UNEP/OzL.Pro/ExCom/73/54/Add.1
31 octobre 2014

**RAPPORT SUR L'INDICATEUR DES CONSÉQUENCES SUR LE CLIMAT
DU FONDS MULTILATÉRAL (DÉCISION 69/23)**

Review of the Multilateral Fund Climate Impact Indicator (MCII)

Total lifetime climate impact of one year of production [tCO2e]

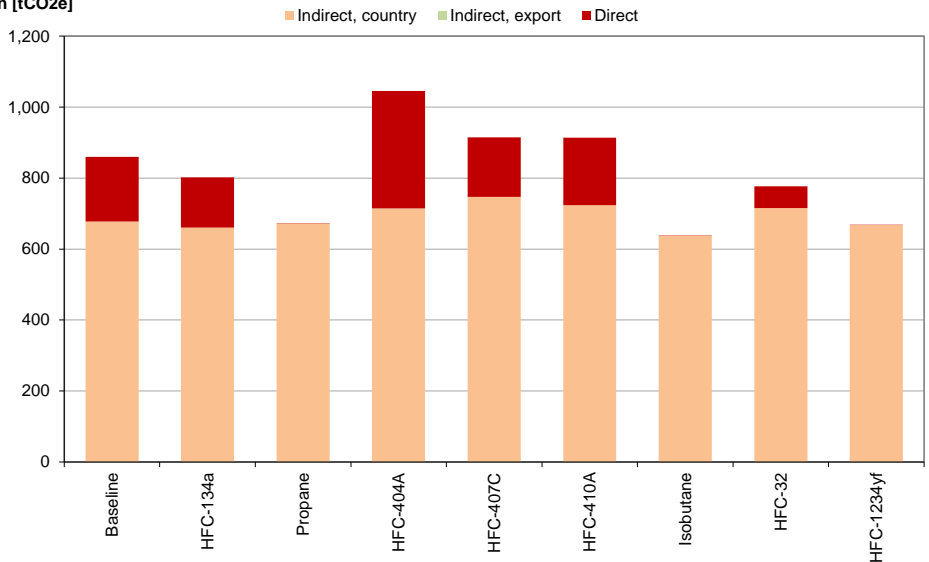
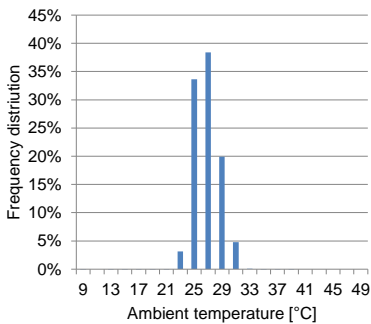
To review results generated by MCII, I performed an analysis for an air-conditioning unit in Seychelles (attached). My observation is that the obtained results on indirect impact for different fluids are not correct to a degree that will provide incorrect relative rankings of alternative fluids.

The MCII analysis shows that the transition from R22 to isobutane and R-1234yf will result in a reduced indirect effect, i.e., improved equipment efficiency. On the other hand, transition from R22 to R410A and R32 will result in an efficiency decrease, while a change from R22 to propane will be efficiency neutral. These results correlate with critical temperatures of the analyzed fluids (fluids with a lower T_{crit} (R410A and R32) have a lower efficiency than fluids with a high T_{crit} (R134a, isobutene and R1234yf); because of the modeling methodology they may correctly represent relative performance of these fluids in chiller systems employing shell-and-tube heat exchangers (pool-boiling and space-condensation refrigerant heat transfer).

However, the obtained results are in disagreement with the current recognition of relative merits of refrigerants applied in systems using optimized serpentine heat exchangers (forced convection evaporation and condensation heat transfer), such as residential and small commercial units. To start with propane, the literature is full of claims of propane having a 5 % - 10 % better efficiency than R22². Regarding R410A, the industry learned to optimize R410A heat exchangers and to match COP_{R22} with R410A systems. Our 2006 study³ confirmed the COP equivalency between R22 and R410A. It also indicated that R134a and isobutene will underperform R22, propane and R410A in an optimized system (when transport properties and system effects are accounted for), while the MCII model predicts isobutene and R134a to be the most efficient fluids.

In conclusions, I believe that the MCII overrates low-pressure fluids (such as R134a, isobutane, and R1234yf) and underrates high-pressure fluids (R410A, R404A, and R32) by not considering the dT_{sat}/dP relationship.
